PROJECT:	Union Bank & Trust	PROJECT NO.	M13455
FROM:	BVH Architects	DATE:	06/19/2014
		ADDENDUM NO.	002

LAYOUT PLAN
SCALE: 1" = 10'

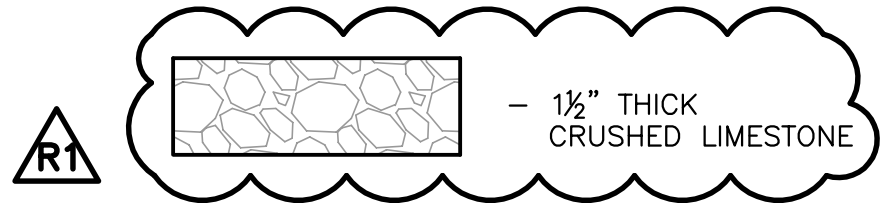
1. C1.1 - Layout Plan
 - a. Please see attached for revisions to the above referenced drawing.
2. C1.2 –Grading Plan
 - a. Please see attached for revisions to the above referenced drawing.

ISSUED FOR:	DATE:	BY:
ADDED 1 1/2" THICK CRUSHED LIMESTONE TO ALLEY, ADD ROCK SYMBOL TO LEGEND.	06/18/14	SDB

GRADING PLAN

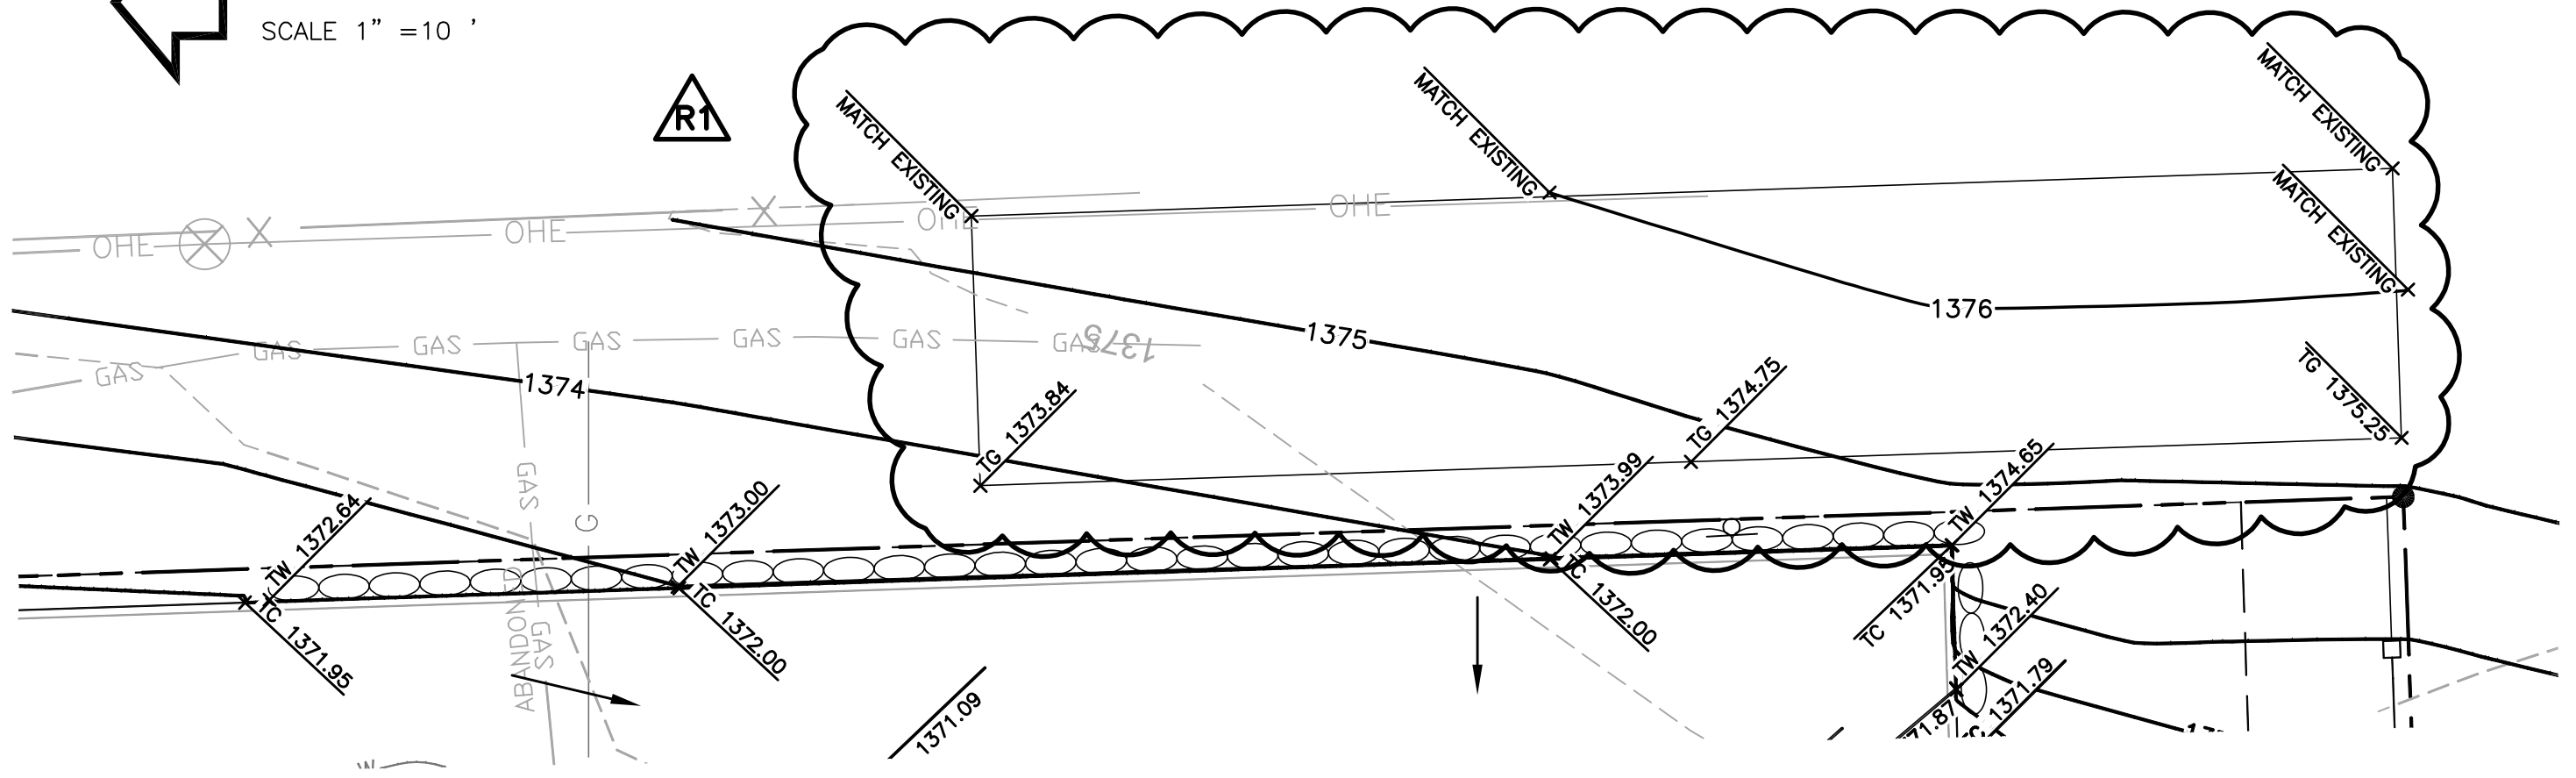
ISSUED FOR:	DATE:	BY:
ADDED GRADES FOR 1 1/2" THICK CRUSHED LIMESTONE ROCK IN ALLEY, ADDED TOP OF SPOT ROCK ELEVATION TO LEGEND.	06/18/14	SDB
